**SOILS AND GEOLOGY STUDY
MONUMENT RIDGE EAST – FILING NO. 1
MONUMENT HILL ROAD AND PALMER DIVIDE ROAD
EL PASO COUNTY, COLORADO**

March 7, 2023
Revised August 7, 2024
Revised July 16, 2026

PCD No. SF2514

**APPENDIX E: Entech Response Letter to CGS Review
dated June 13, 2024**

FIG. 6

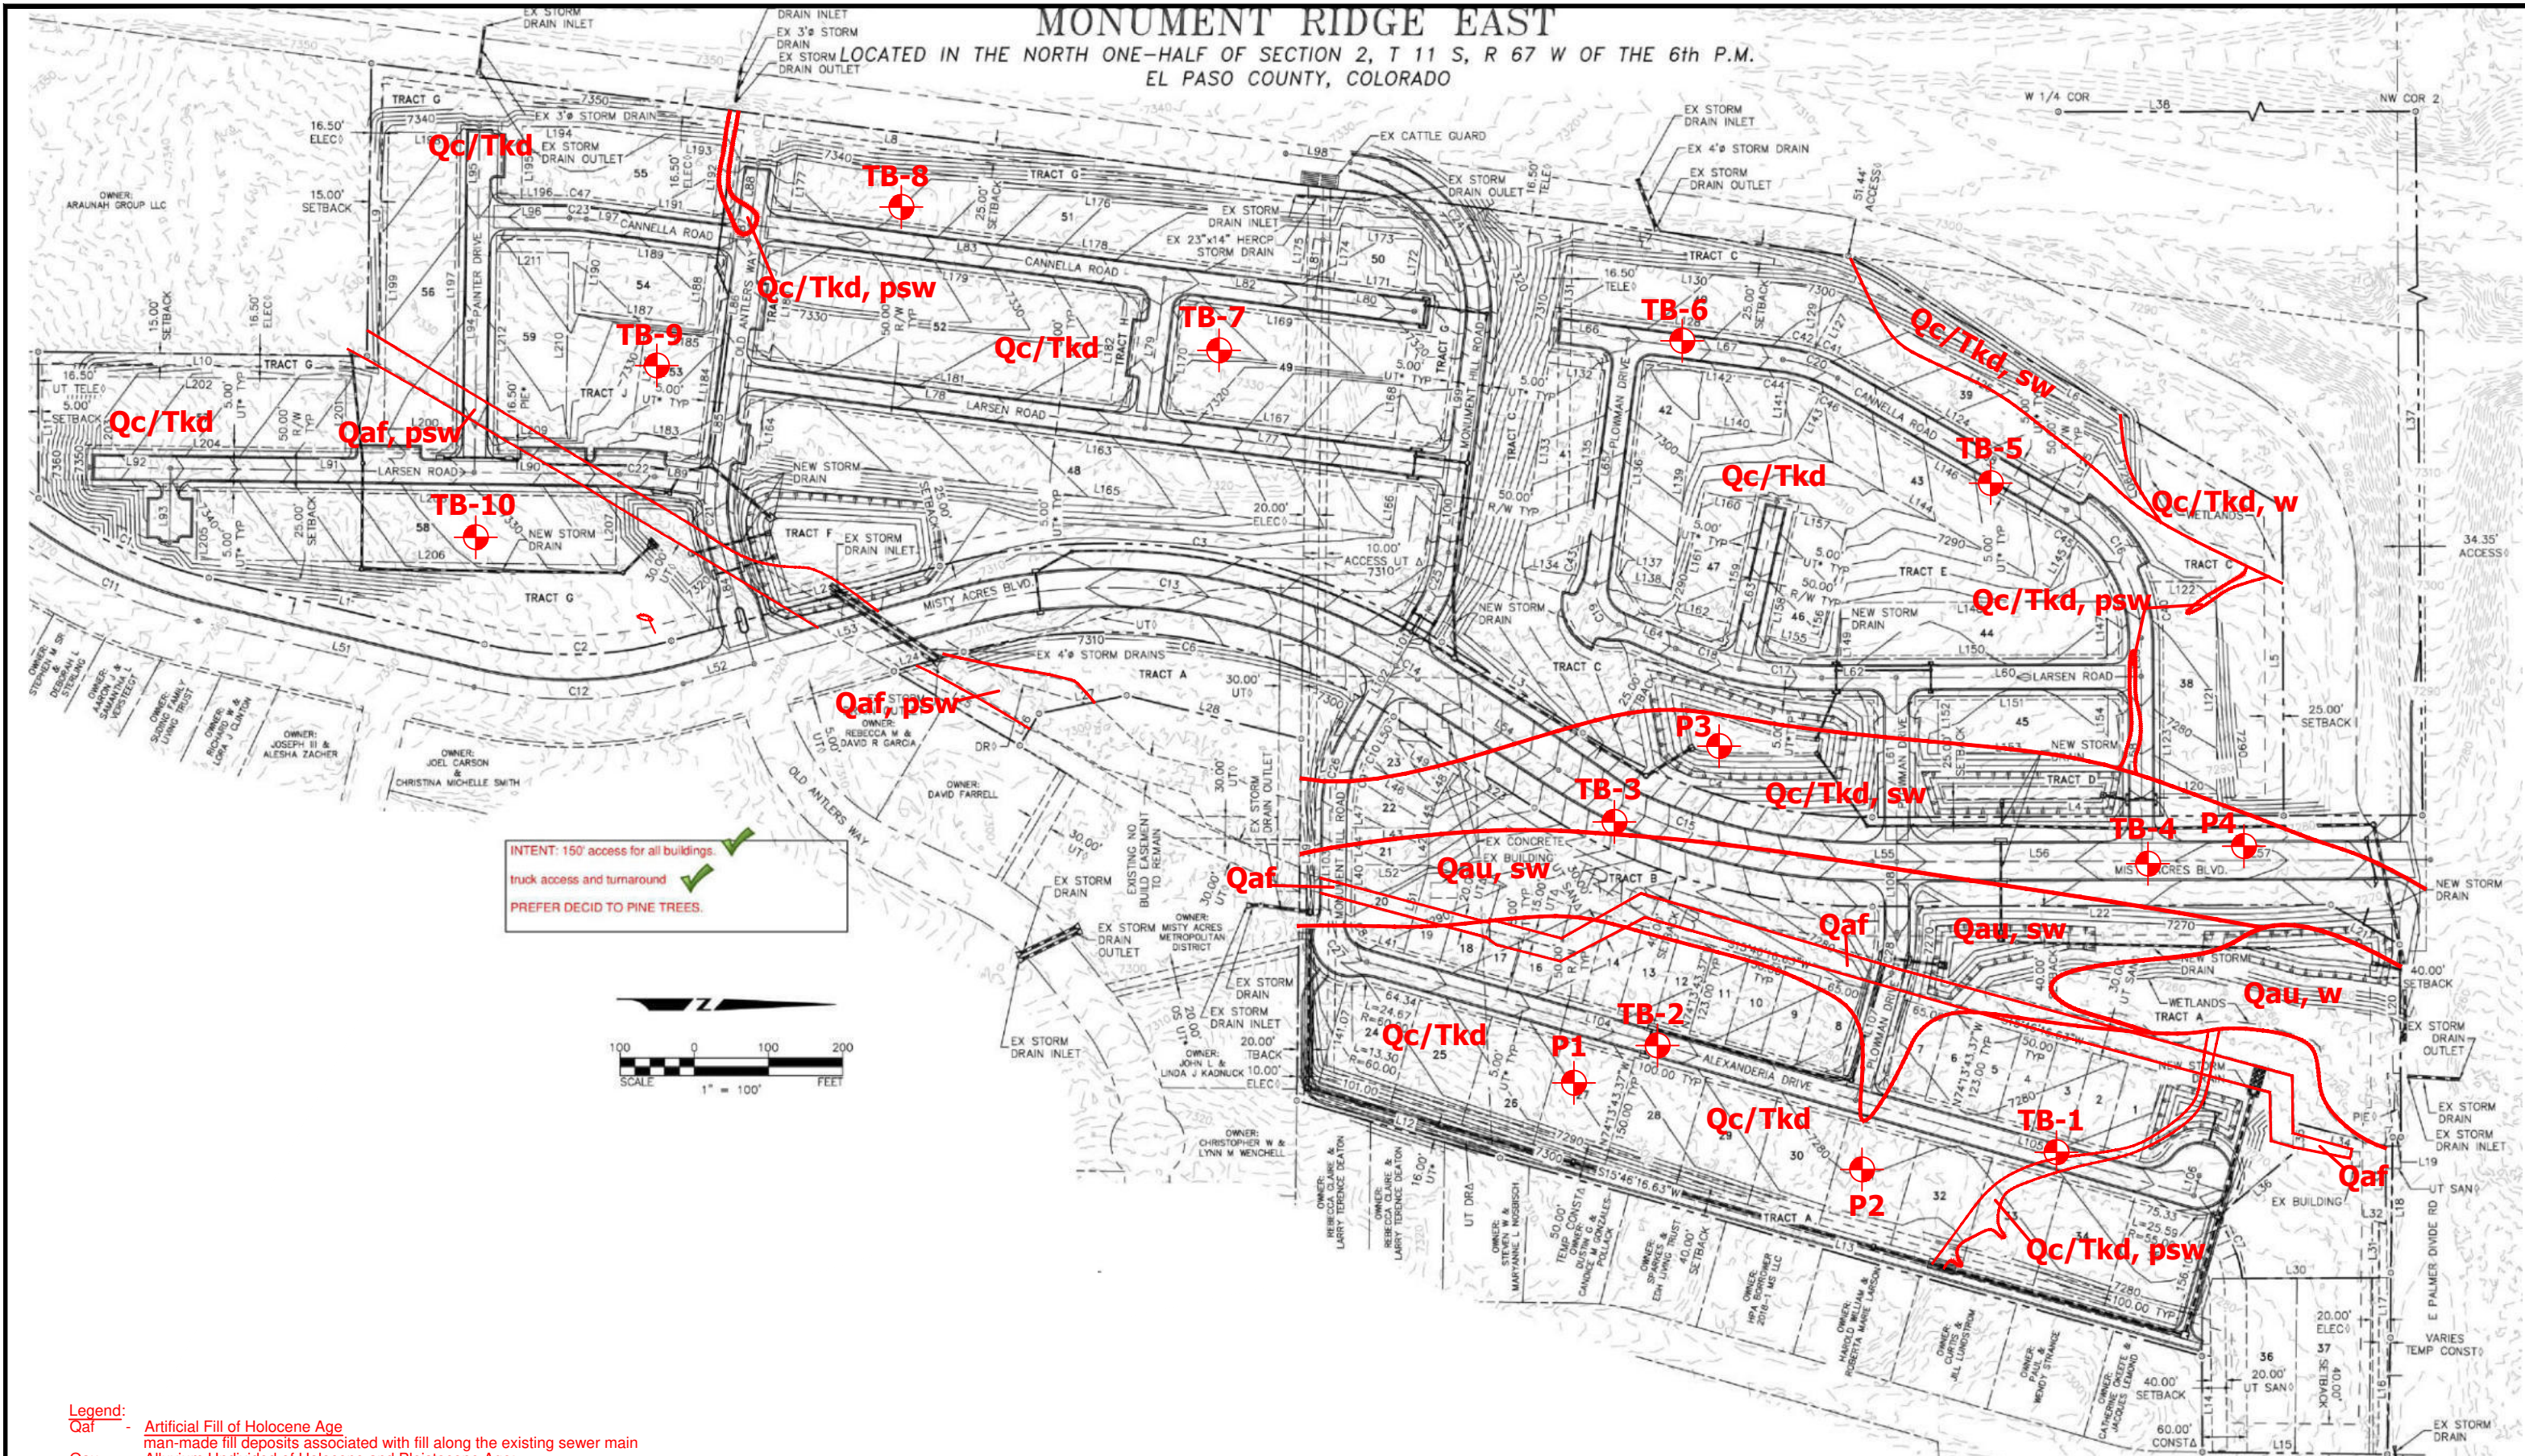
1. Entech encountered groundwater at depths ranging from 1 to 10 feet during drilling. However, figure 7 of their report fails to depict this shallow groundwater in the relevant areas. Test Boring No. 3, which includes groundwater at 1 foot, is mapped as Colluvium and Dawson Formation without shallow groundwater. It is imperative that Figure 7 is revised to reflect the geologic hazards and constraints.

4. A geologic hazard note is not included in the preliminary plan drawings. CGS recommends updating Figure 7 of Entech’s report and adding a note to the preliminary plan/plat listing the geologic hazards and constraints, along with mitigation measures.

5. Wetlands (Freshwater Emergent/Freshwater Forested/Shrub Wetland) are located within the site. However, these areas do not appear to be portrayed correctly in Figure 7 of Entech’s report. These areas are associated with standing water; lots should not be located within these areas, a setback should be established, and these areas should be designated as “No Build Areas”. Setbacks and no build areas should be noted on the plans.

Entech Response to Comment 1: The Geology/Engineering Geology Map has been updated and is included with the revised report.

Entech Response to Comment 4: Figure 7 has been updated, and a geologic hazard note provided for the preliminary plan/plat.

Entech Response to Comment 5: Entech is in agreement that lots should not be located within the delineated jurisdictional wetlands located in the northern and northwestern portions of the site. The jurisdictional wetlands lie within no-build areas and will be avoided by the development.
